# LOWER MINNESOTA RIVER WATERSHED DISTRICT

Lower Minnesota River Watershed District Board of Managers Meeting

#### Item 6. F. - Project Reviews

**PURPOSE:** Construction Stormwater Site Visit on Behalf of the Lower Minnesota River Watershed District (LMRWD)

CenterPoint Energy sign placement map

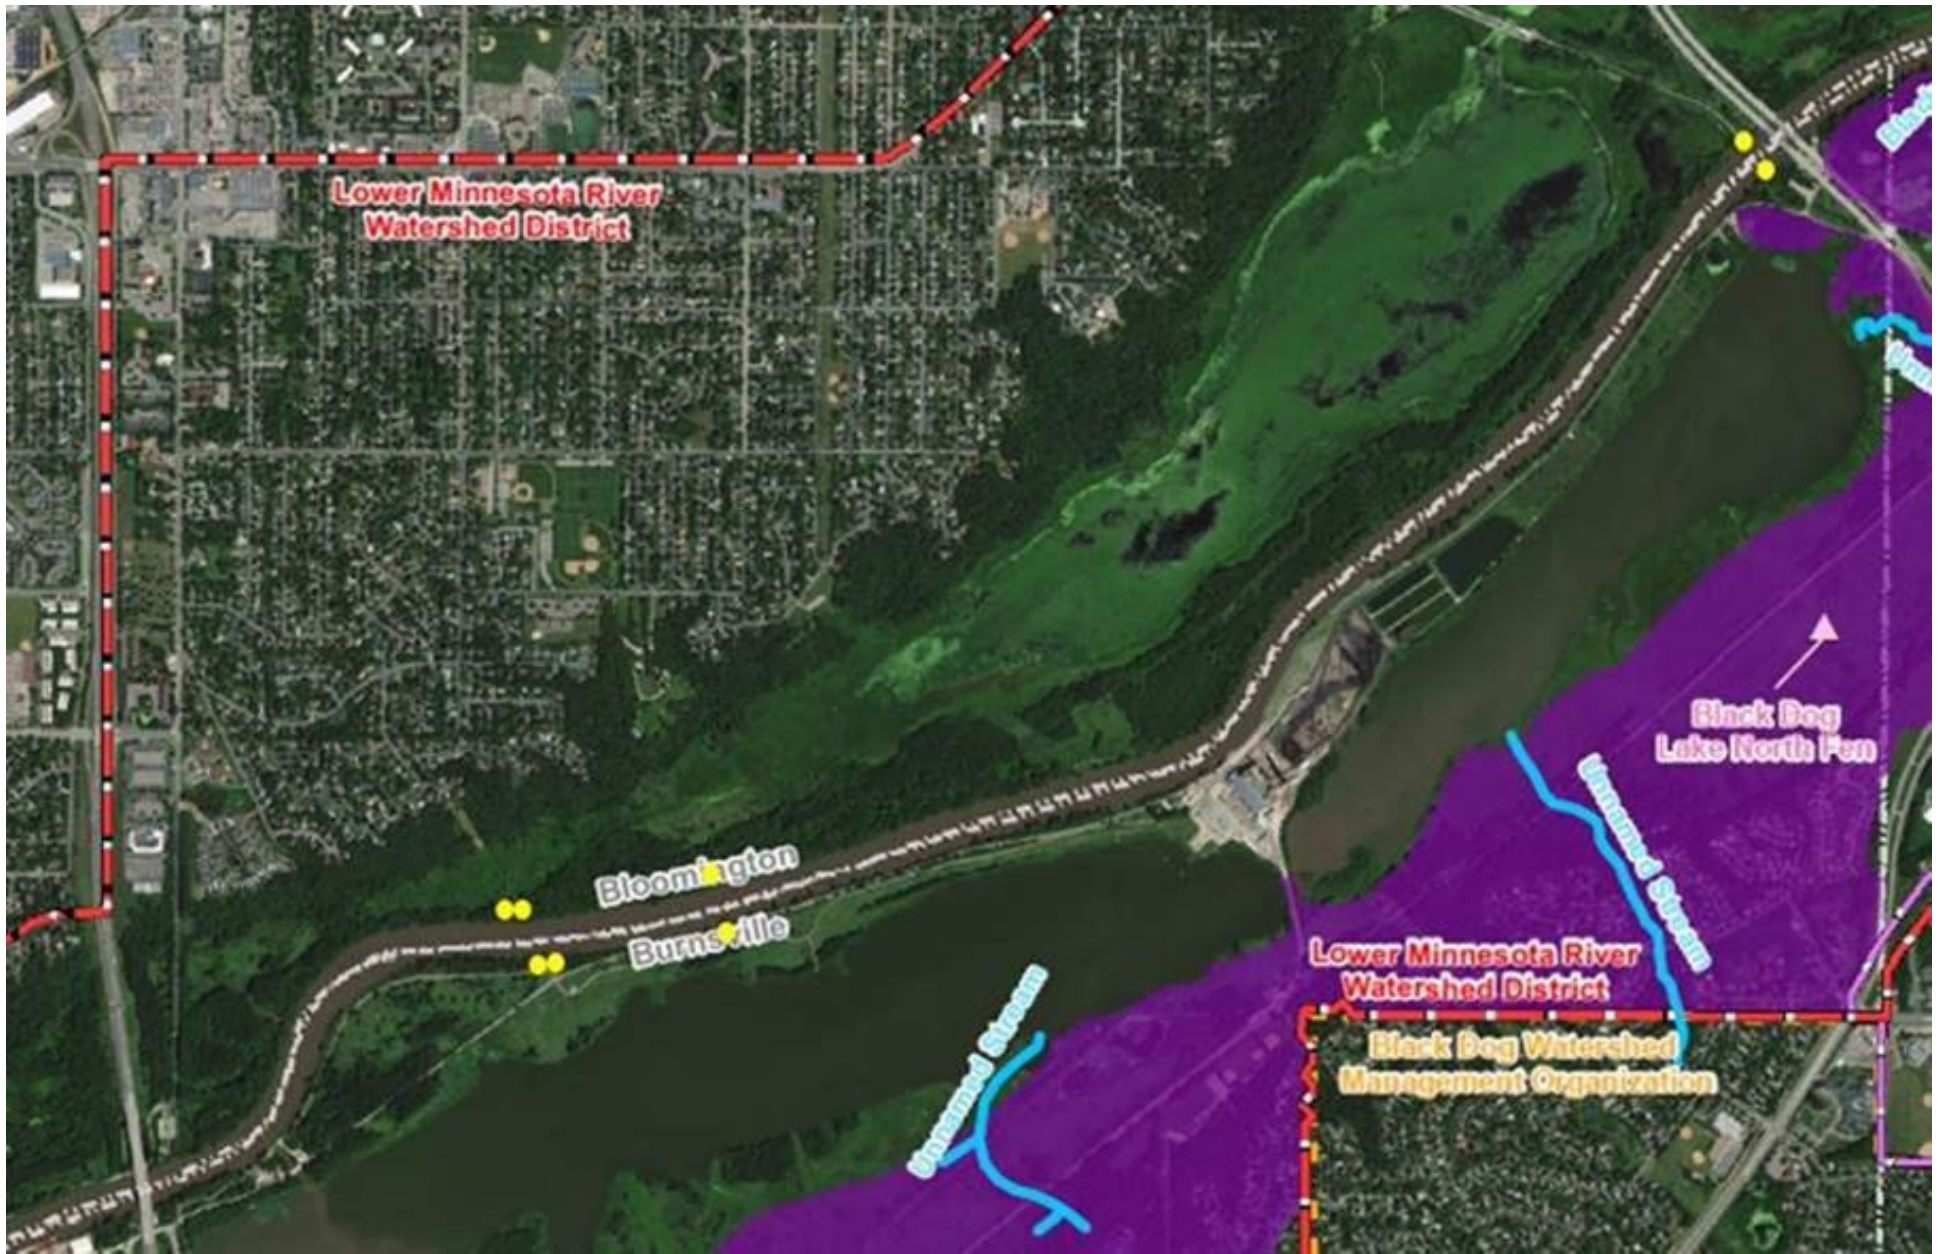
CenterPoint Energy is proposing to replace a total of eight (8) signs on top of the north and south banks of the Minnesota River that mark the locations of existing natural gas pipelines within existing pipeline easements. Staff confirmed the signs are located outside of the High Value Resource Area (HVRA) defined in Appendix K of the Lower Minnesota River Watershed District (LMRWD) Watershed Management Standards (a map is attached; yellow circles are approximate sign locations, the purple shaded area is the HVRA).
